Docket Item #6A-D

Hoffman Town Center – Block 8
Master Plan Amendment #2011-0005
CDD Concept Plan CDD #2011-0004
Development Special Use Permit #2011-0020
Transportation Management Plan SUP#2011-0046

MPA #2011-0005
DSUP #2011-0020
CDD CONCEPT PLAN #2011-0004
SUP TMP #2011-0046

Original Eisenhower Avenue Elevation

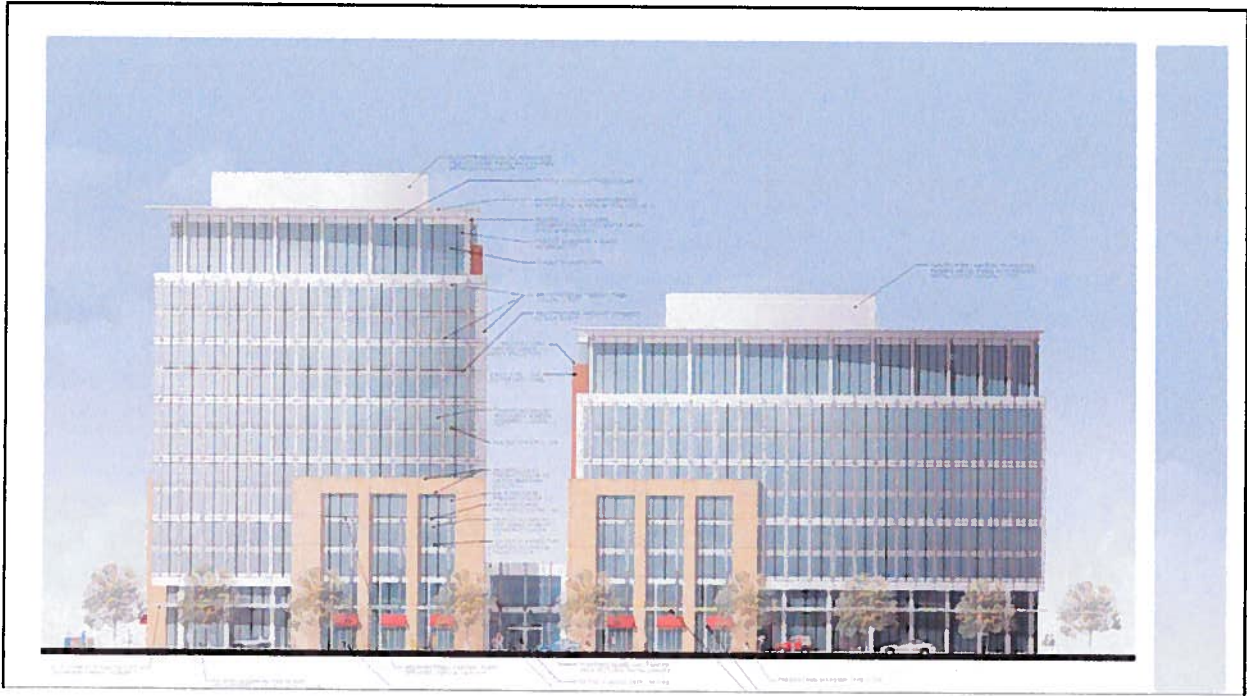
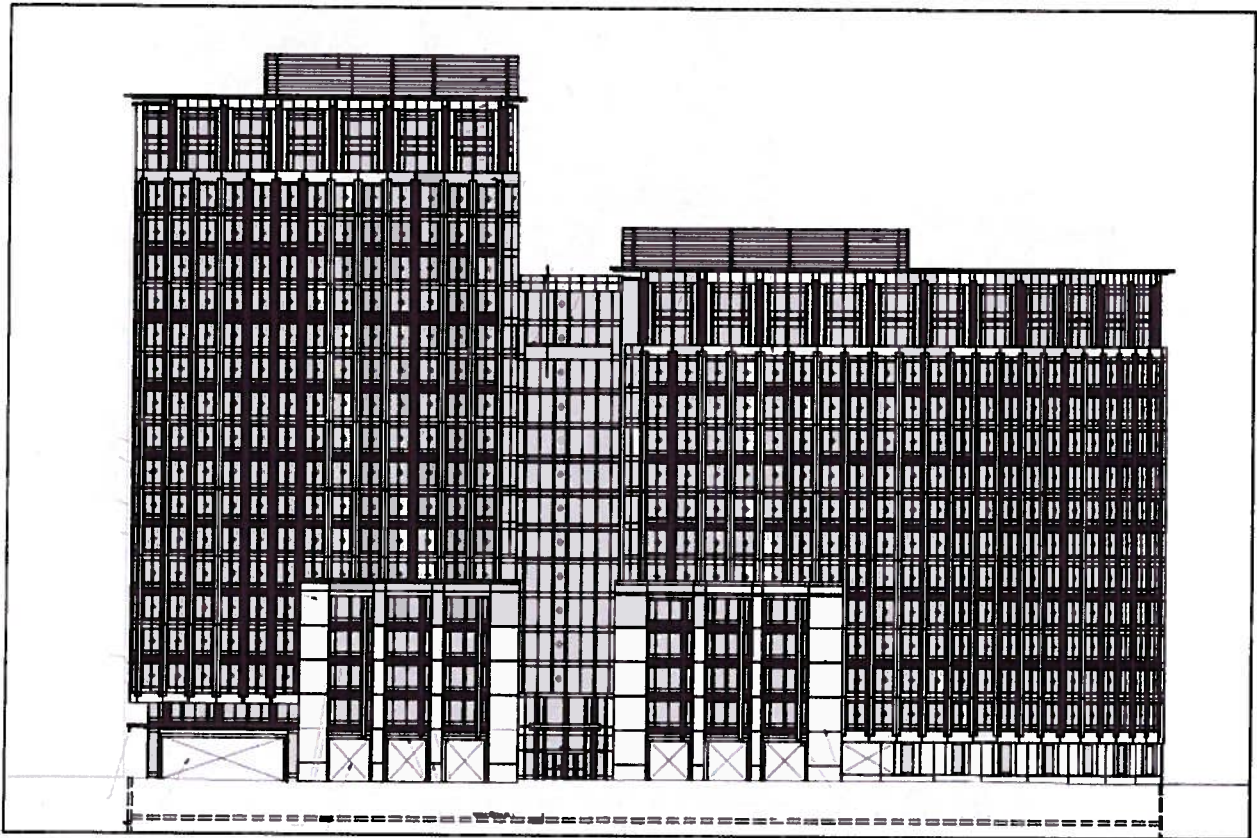
Staff also supports the vertical extension of the atrium component. With this revision, the space between the two towers would be occupied by office floor area and the floor plates between the two towers would be connected. While this does not provide the separation of the towers that occurred in the original proposal, this change is necessary to accommodate the GSA tenant since it provides the additional floor area and internal connections that the two separate towers do not. The atrium component is inset between the two towers along the Eisenhower Avenue frontage approximately 25 feet from the eastern tower and approximately 55 feet from the western tower. This recess and the designed offset of the two towers provide a visual separation. Furthermore, the applicant has proposed using spandrel glass for the stories added above the atrium in order to differentiate this recessed area from the two towers and make it more of a background element. The use of precast along the sides of the towers further delineates the extent of the towers.
